**Proposed Minor Relaxation of Building Height Restriction for Permitted Flat Use
Tung Chung Town Lot 49, Tung Chung Road North, Lantau Island
(Section 16 Planning Application No. A/I-TCTC/71)**

- Further Information No. 2 -

**Proposed Minor Relaxation of Building Height Restriction for Permitted Flat Use,
Tung Chung Town Lot 49, Tung Chung Road North, Lantau Island
(Section 16 Planning Application No. A/I-TCTC/71)**

Figure: 2.1d

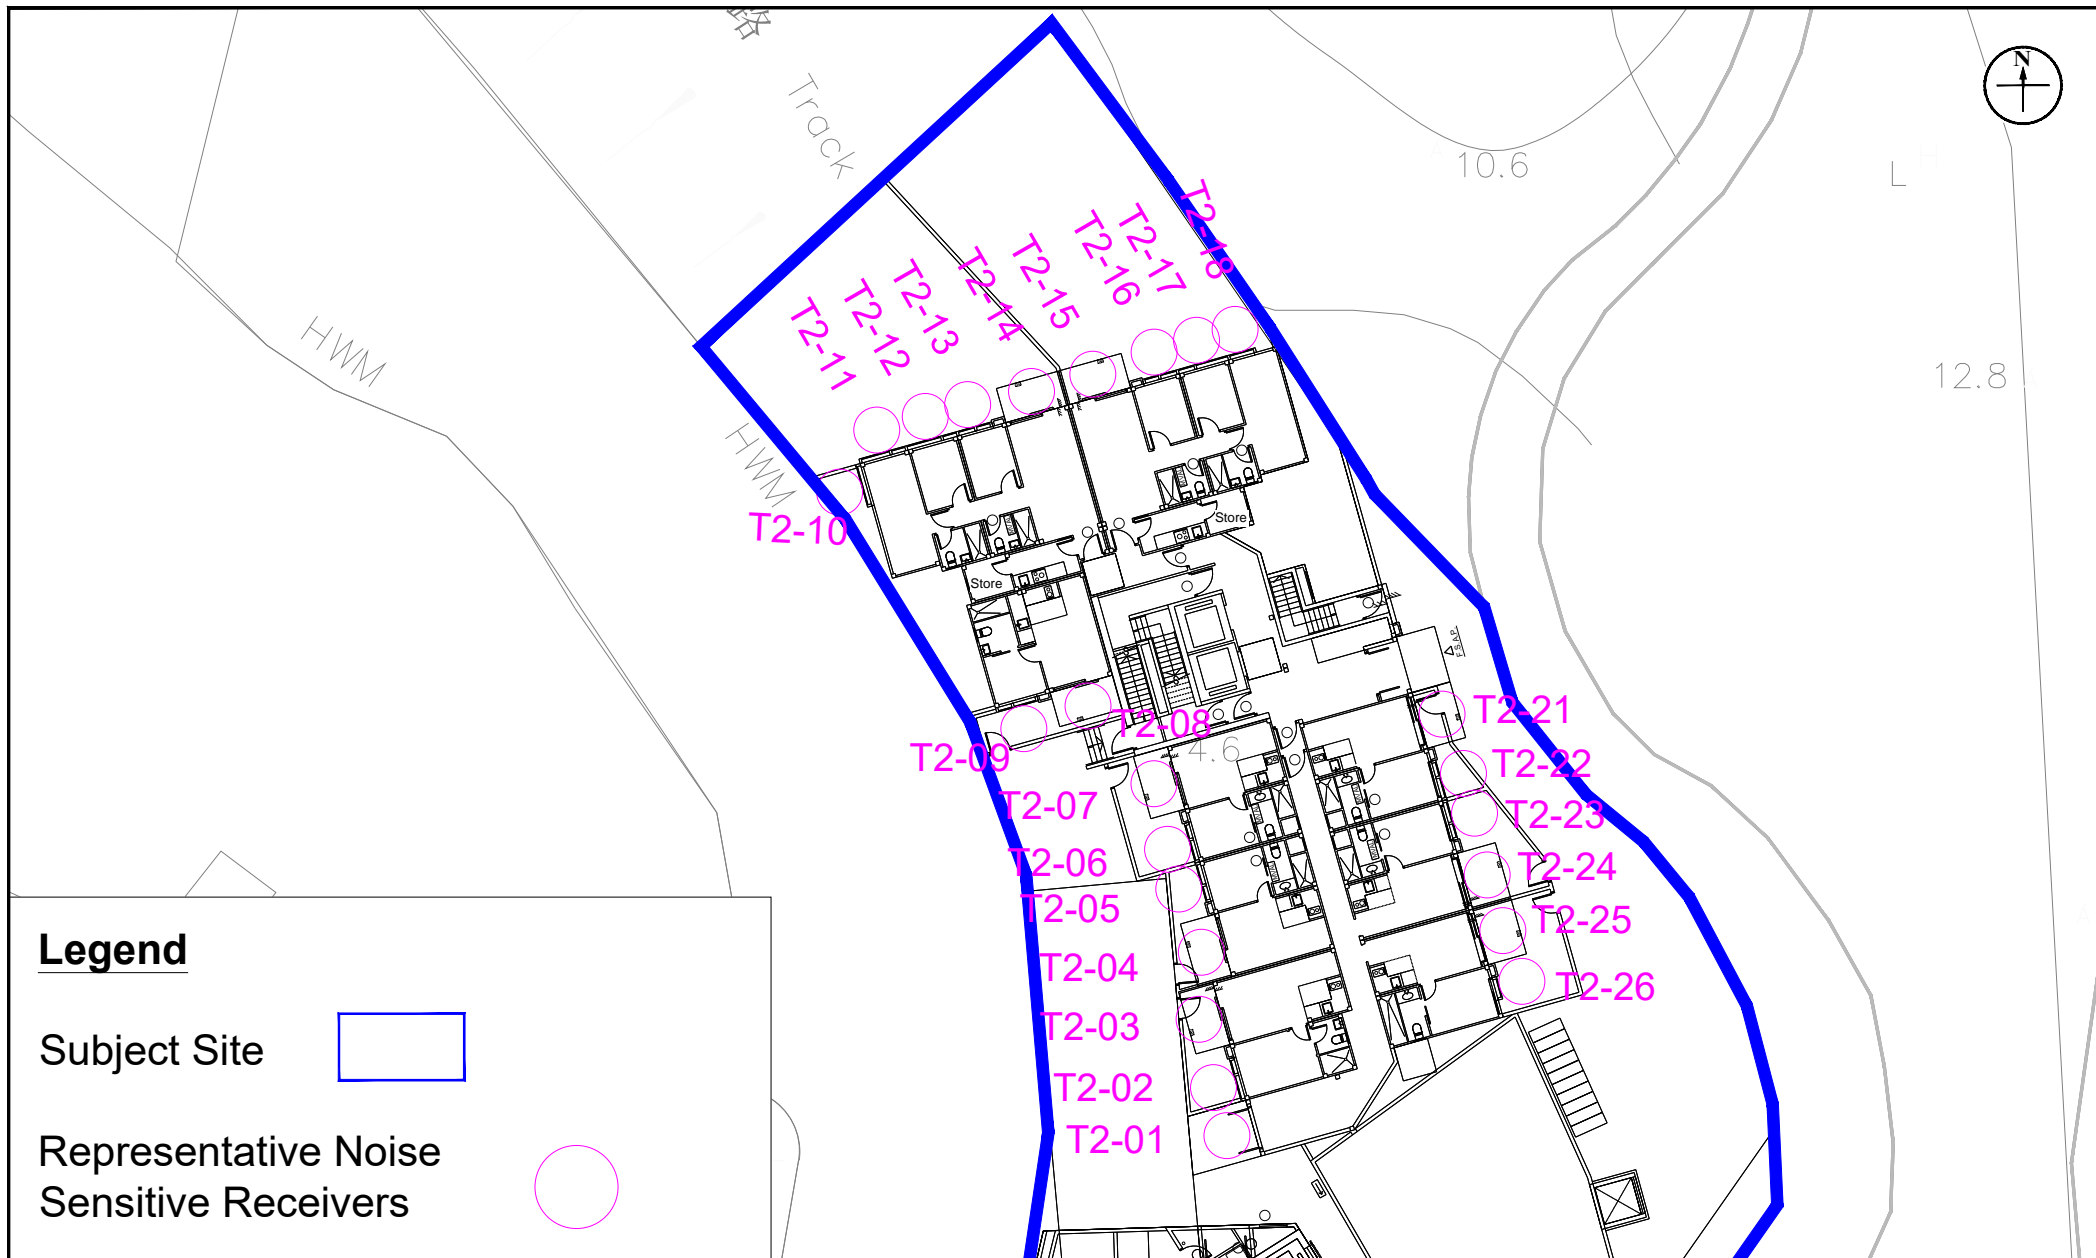
3.19	Re. Figure 2.1d, please review whether locations T2-19 and T2-20 at T2-1/F, which appears to be communal area, are considered as NSRs.	Noted. T2-19 and T2-20 have been removed from Figure 2.1d of the EA.

Figure: 3.2

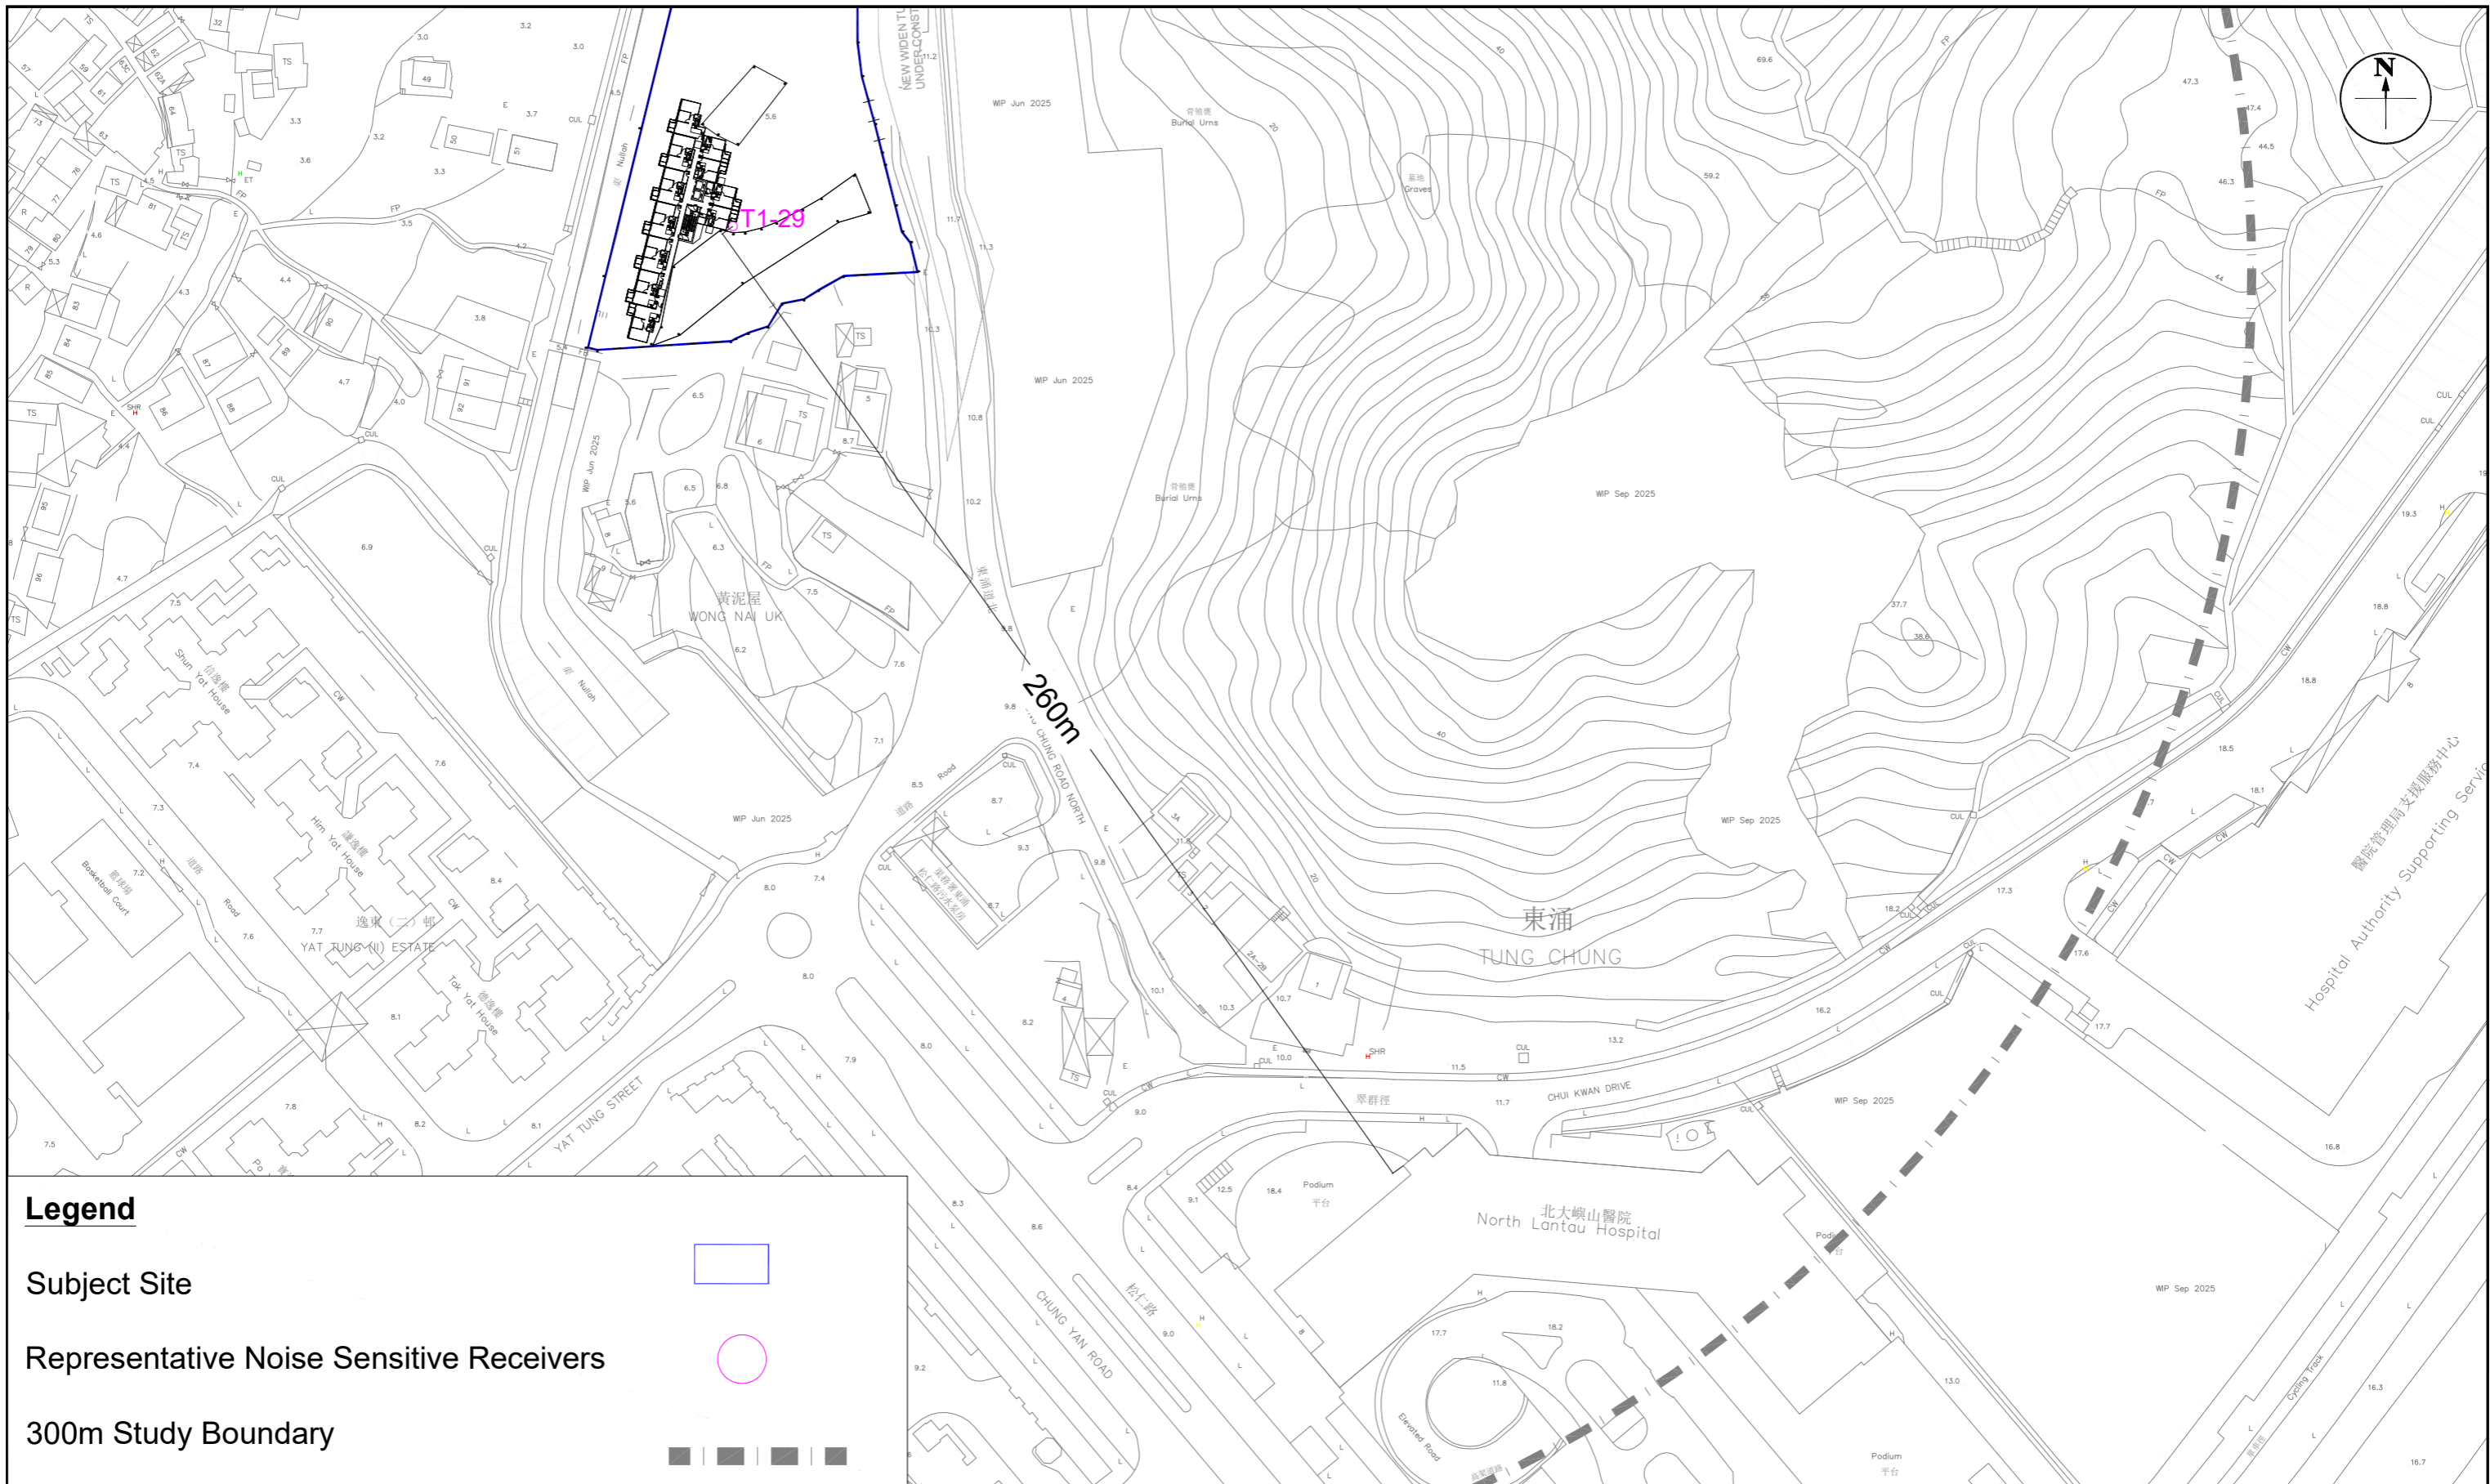
3.21	Re. S 3 Fixed noise source impact assessment, please address the potential fixed noise source impact (e.g. outdoor E&M plants) from the North Lantau Hospital.	Noted. S.3.2.4 and Figure 3.2 of the EA have been supplemented to address potential fixed noise source impact from the North Lantau Hospital.

Figure: 4.2

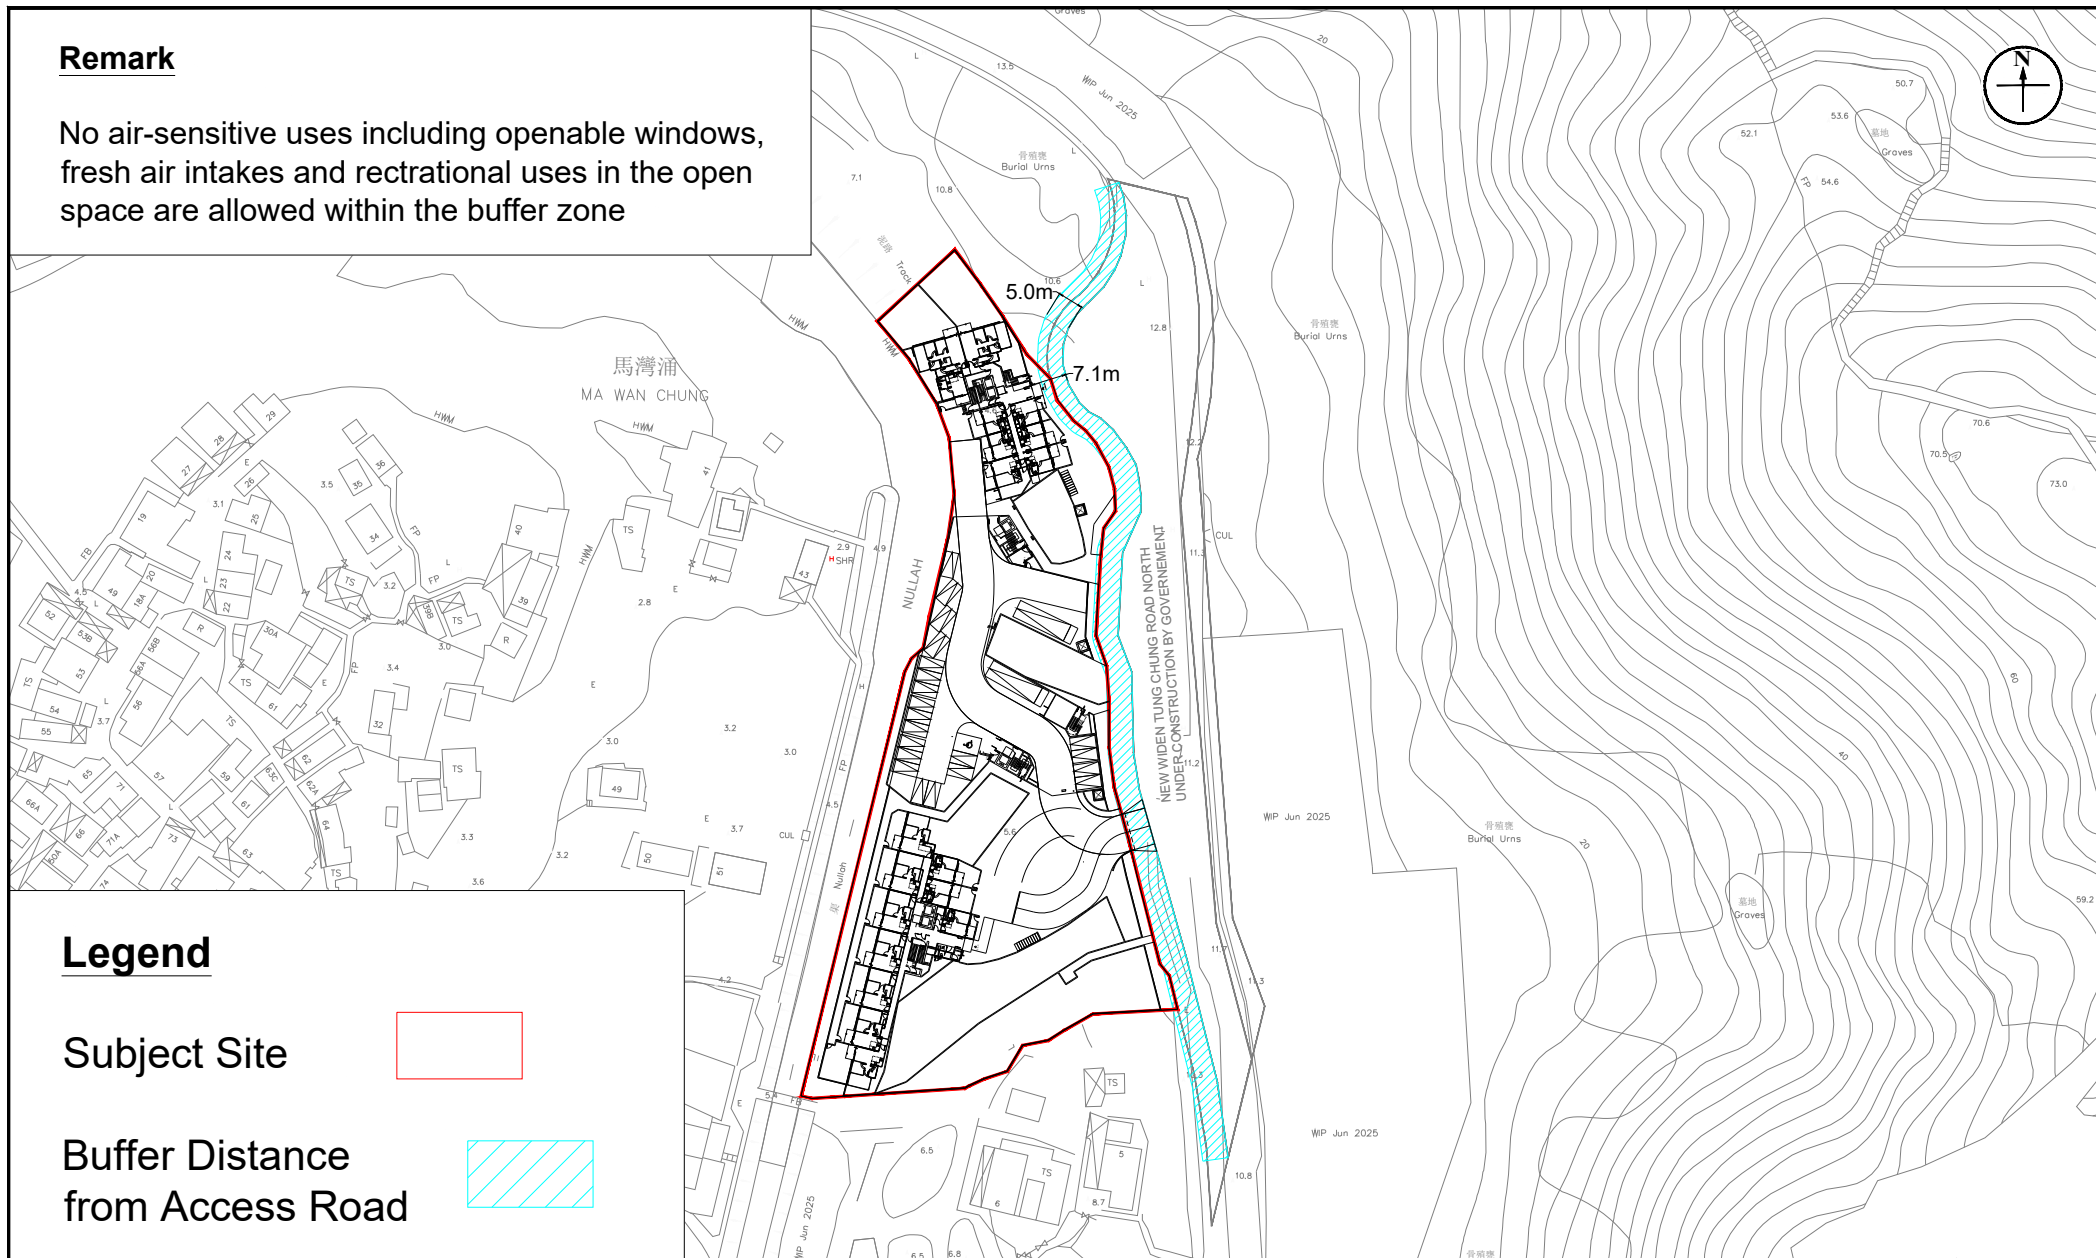
Item	Comments	Responses
3.14	Figure 4.2 – Please remove the separation distance 235m, which is no included in Table 4.8.	Noted and Figure 4.2 of the EA has been updated accordingly.

Figure: 4.5

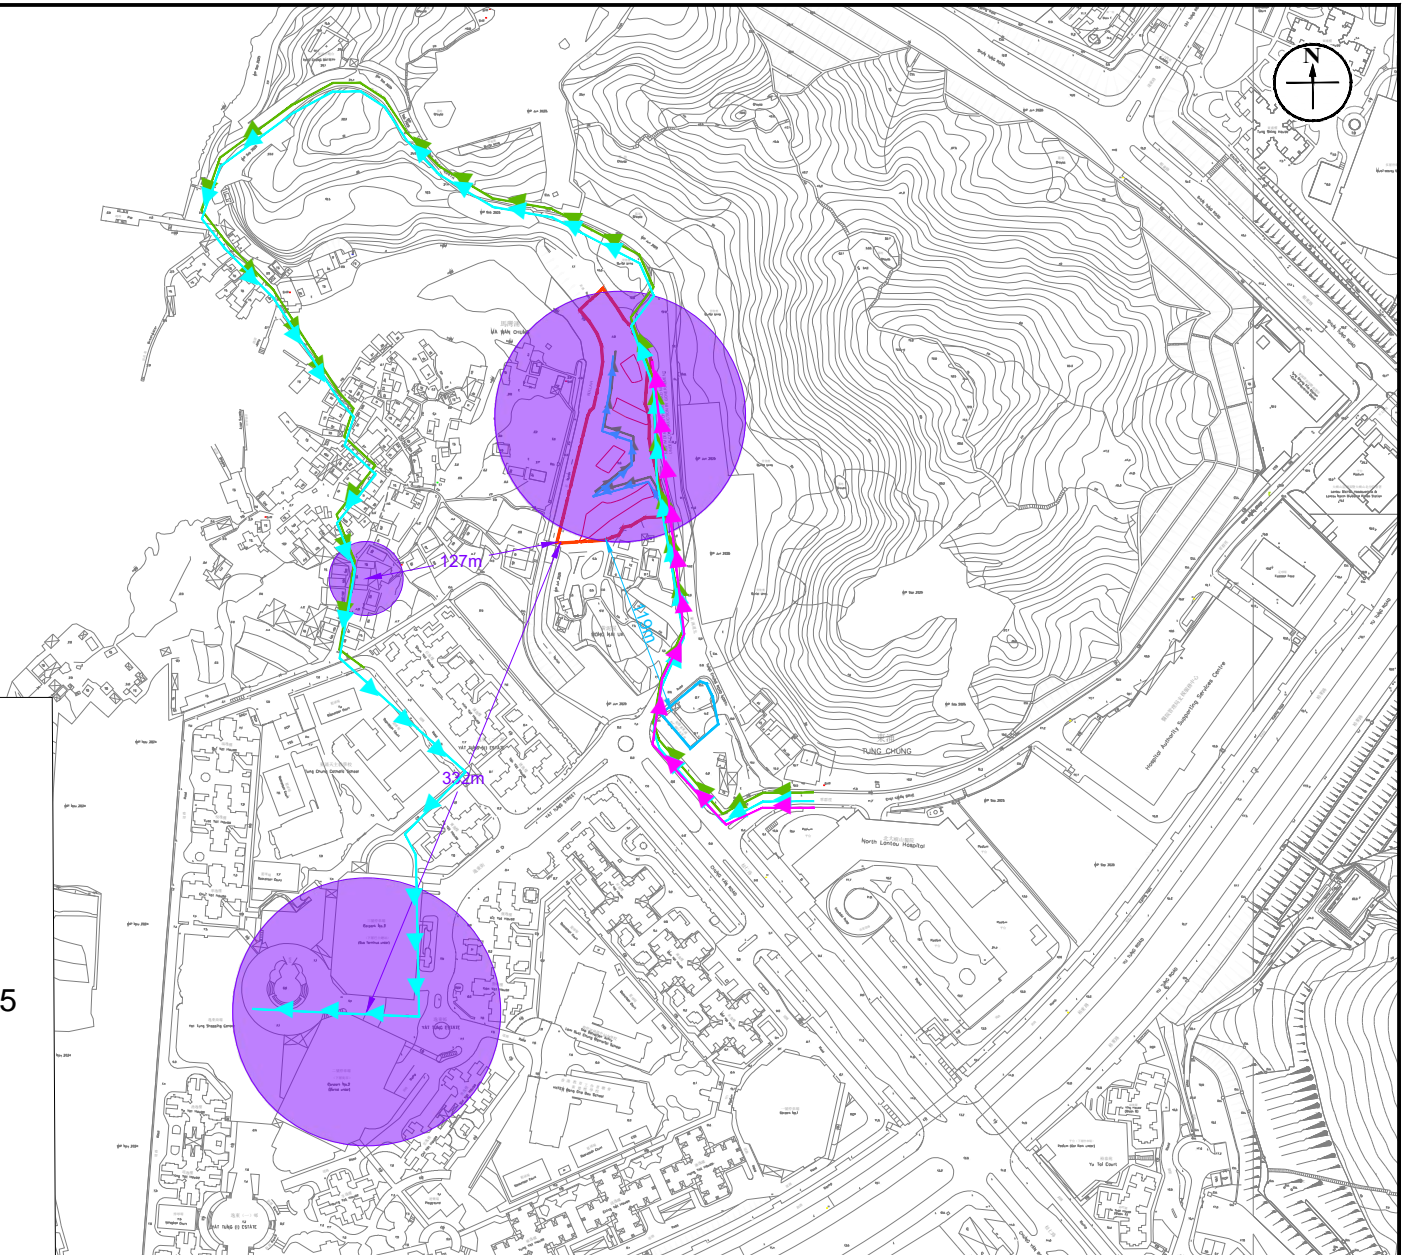
3.15	Figure 4.5 – Please indicate 200m buffer distance in the figure.	Noted and 200m and 500m buffer distance have been shown in Figure 4.5 of the EA accordingly.
